Office Action Summary

10/099,775

KLING, JEAN-CHRISTOPHE
JACQUES

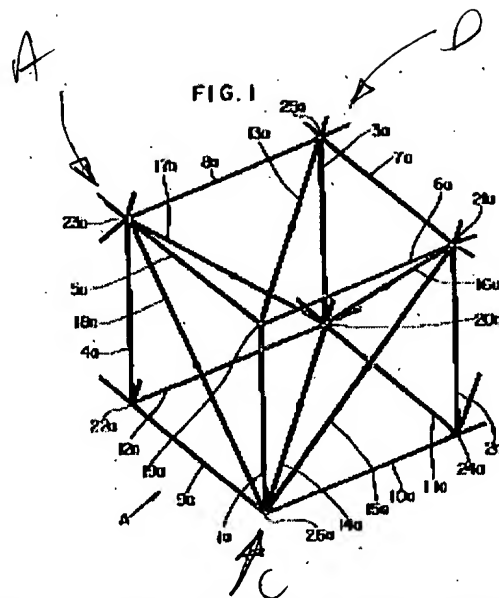
Claims 1-5,7-24 are rejected under 35 U.S.C. 103(a) as being unpatentable over US Patent #4,819,399 to ONODA. ONODA discloses the use of an architectural system including a triangular base (ABC) consisting of a first (17a), second (14a) and third (18a) strut aligned along first (AB), second (BC), and third (CA) axis; such that the first and third struts (17a,18a) form a first acute base angle (CAB), the first and second (17a,14a) struts form a second acute base angle (ABC), and the second and third struts (14a,18a) form a third acute base angle (BCA), see below; wherein the struts

(17a, 14a, 18a) each consist of at least two rigid pieces in that they can be folded (column 8, lines 4-8 and 53-54) and movable apart to form a strut elongation. The structure further includes a first node (A) engaging the first (17a) and third (18a) struts, a second node (B) engaging the first (17a) and second (14a) struts, a third node (C) engaging the second (14a) and third (18a) struts forming the base triangle (ABC) and base plane; and an extension (15a) consisting of a fourth strut aligned along a fourth axis (CD) that does not lie in the base plane of the triangular base (ABC), see the marked attachment. ONODA discloses the basic claimed structure except for explicitly detailing the exact dimensions of the angles forming the base triangle or the angle of the fourth strut. Although ONODA does not detail explicit angles that form the base triangle, it would have been obvious to one having ordinary skill in the art at the time the art was made to select an angle dimension suitable for the use intended as an obvious matter of design choice. For instance, larger width structures a larger angle dimension would be required; however, when a smaller size structure is being formed, a smaller angle dimension would be required. Also, the strength of the member forming the strut

or how the structure is intended to be used will determine the size of the angles that form the triangular base. In reference to claims 2-4, the fourth axis (CD) forms an angle (DBA) with the first axis; however, selection of the angle between the first and fourth axis or the angle of the fourth axis is also a matter of design choice, see also the marked attachment. Further, the applicant discloses a wide range of angle dimensions suitable for selection of the angle between the first and fourth axis, thus the applicant has shown no criticality for the selection of any one desired angle dimension.
